ADDENDUM NO. 4:

Date: February 13, 2026
 Project: Verbena HS Gym
 DCM# 2025629
 WSM# 25-032

Owner: Chilton County Board of Education
 Architect: Ward Scott Morris Architecture, Inc.

PROJECT: Verbena HS Gym	ENG #2559 ARCH #25-032 DCM #2025629	DATE: February 13, 2026
-----------------------------------	---	-----------------------------------

BID DOCUMENTS		
DATE: 01/08/26 PROJ NO: 25-032		
REVISIONS		
#	DESC	DATE
1	ADD 002	02/05/26
2	ADD 004	02/13/26
PRESSURE PLAN		
P201

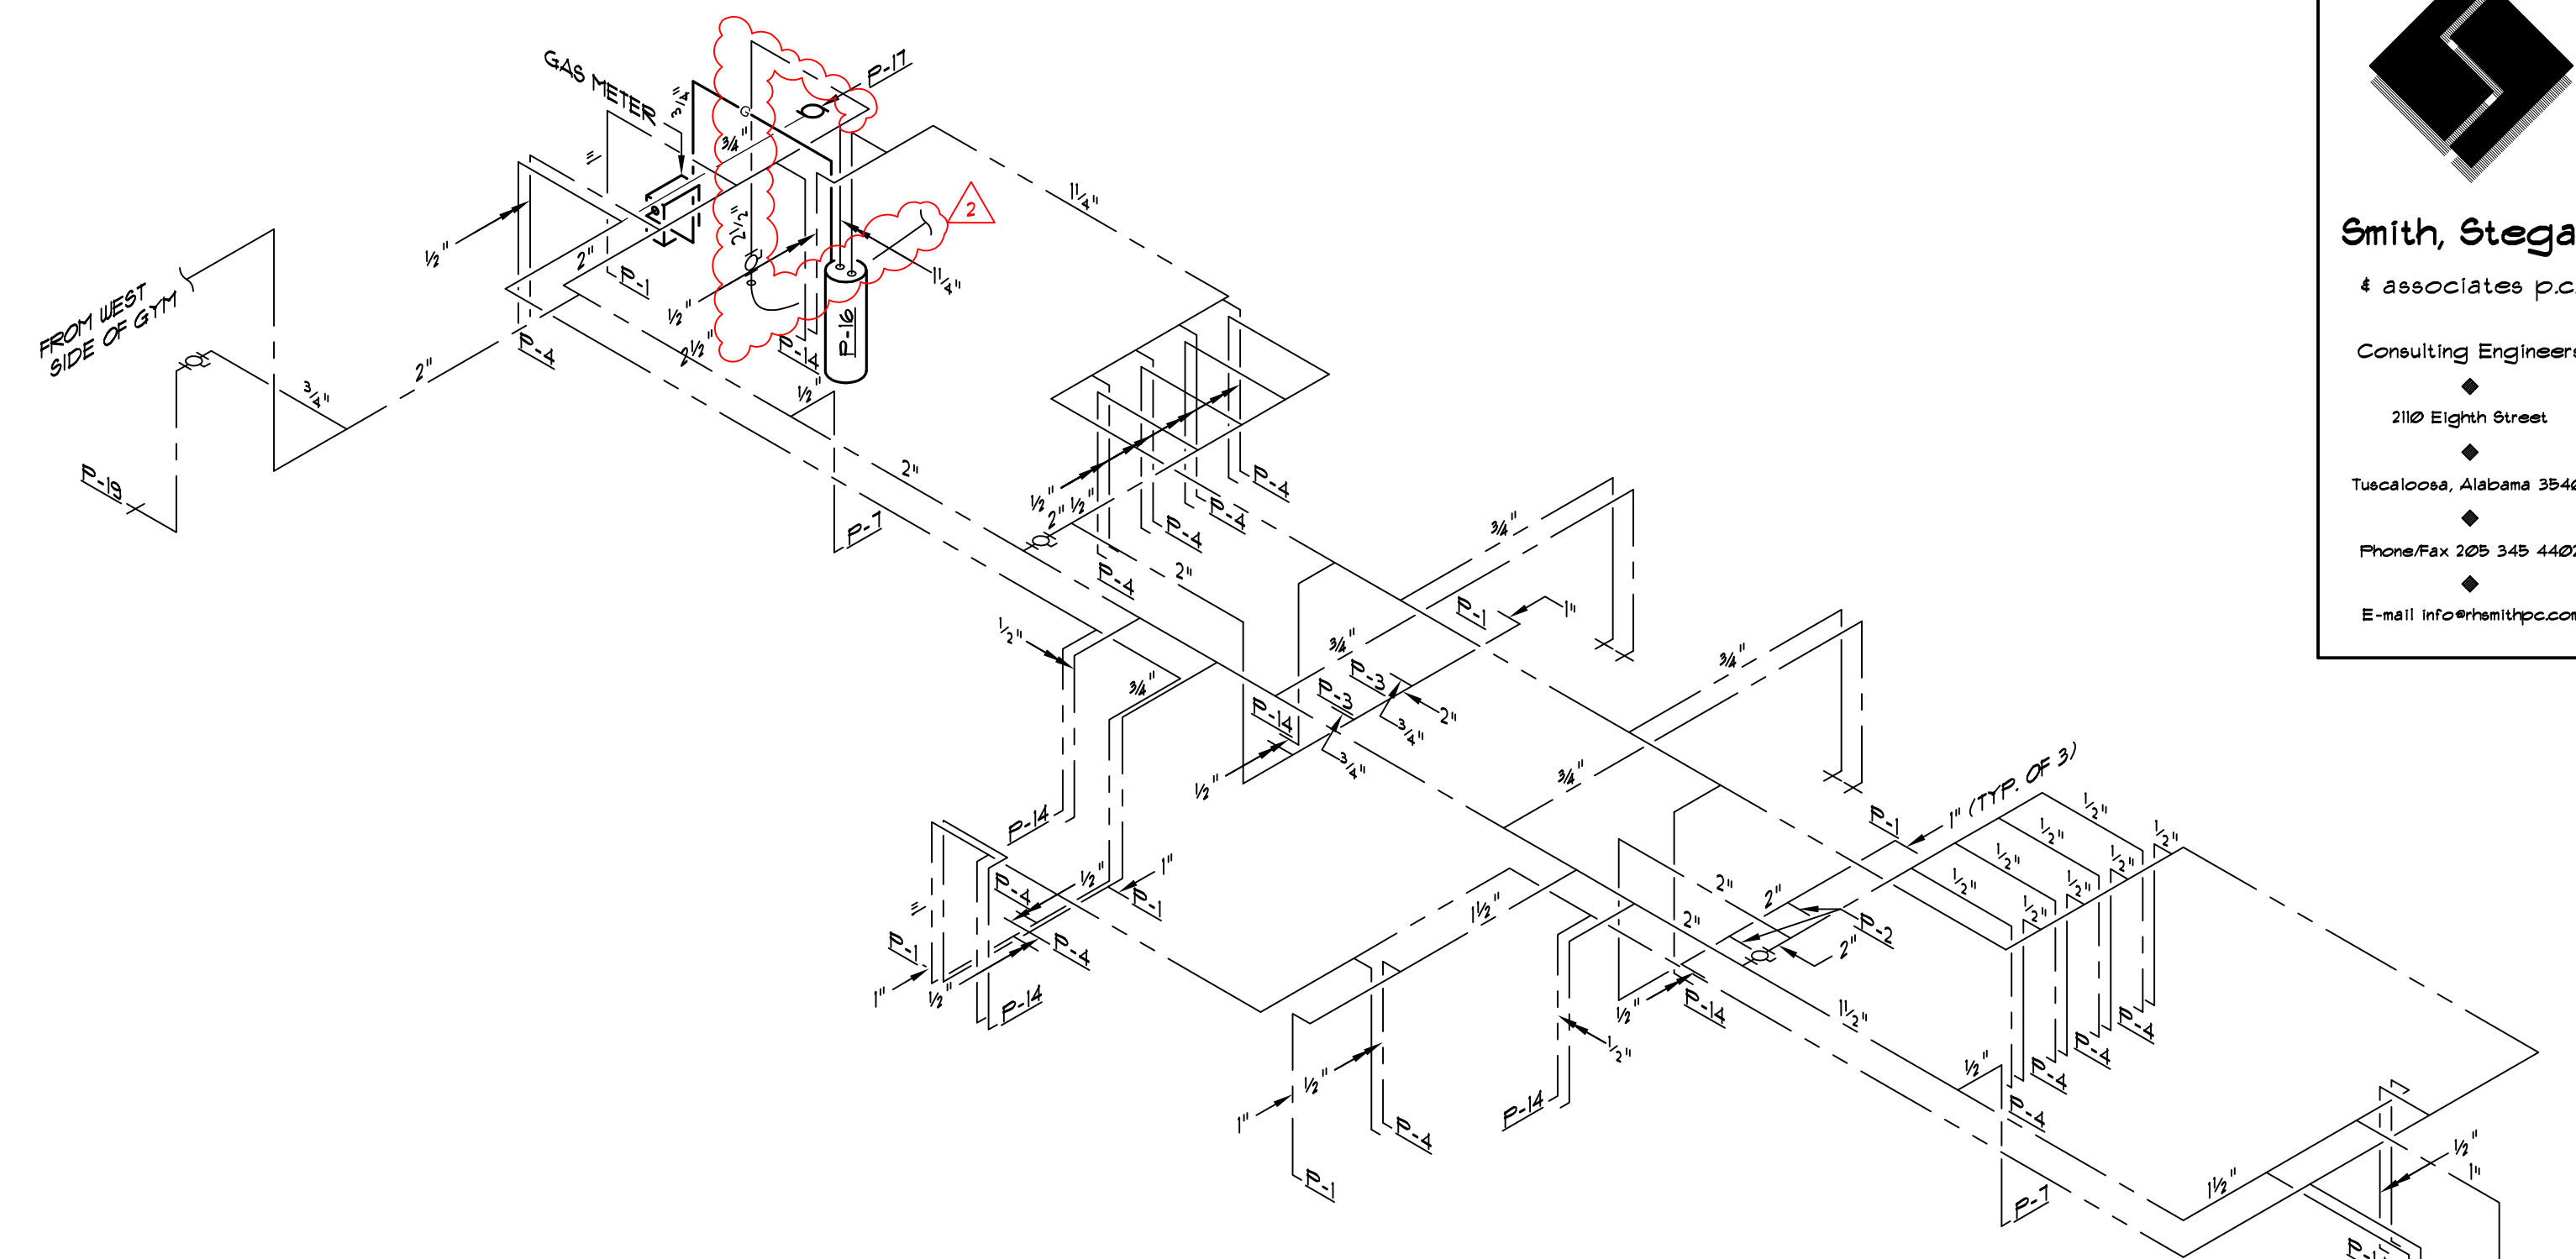
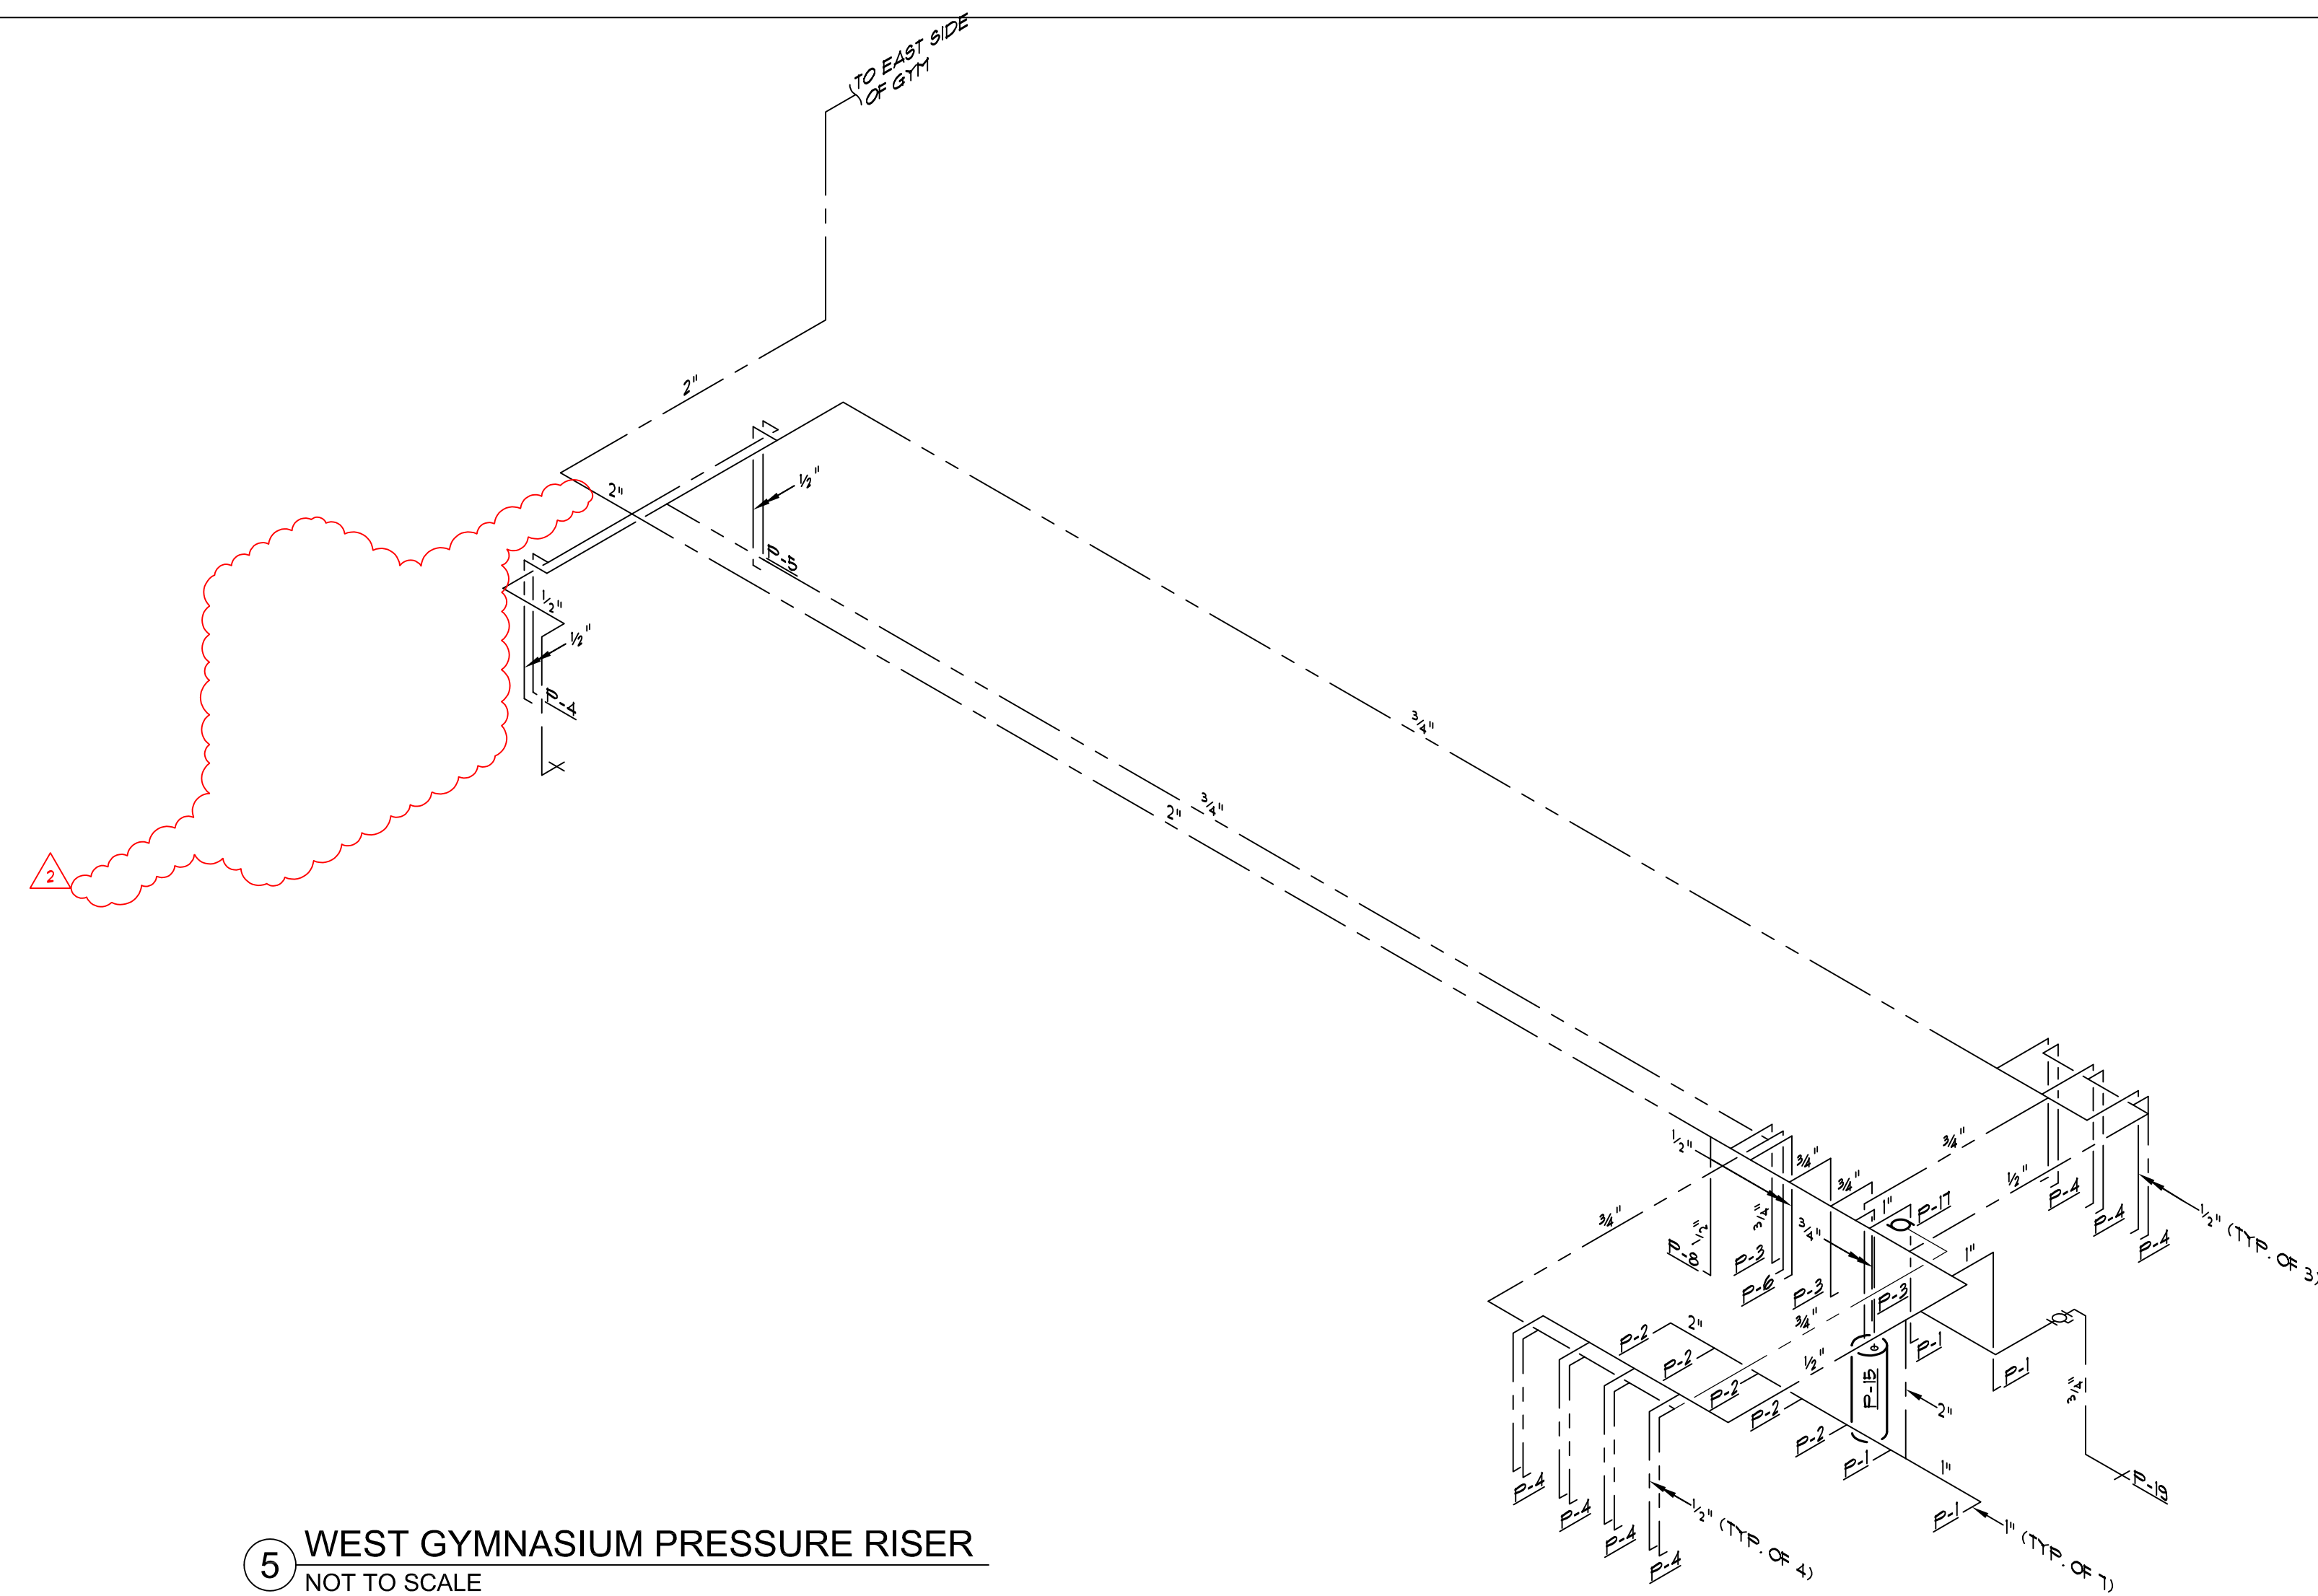
1. Sheet P001: P-17 is recirculating pump for domestic water.
2. Sheet P101: Delete floor drain in former fire pump room.
3. Sheet P201: Delete pressure boosting pump. New water service to area provides 75 PSI.
4. Sheet P201: Relocate water service to Riser 1109
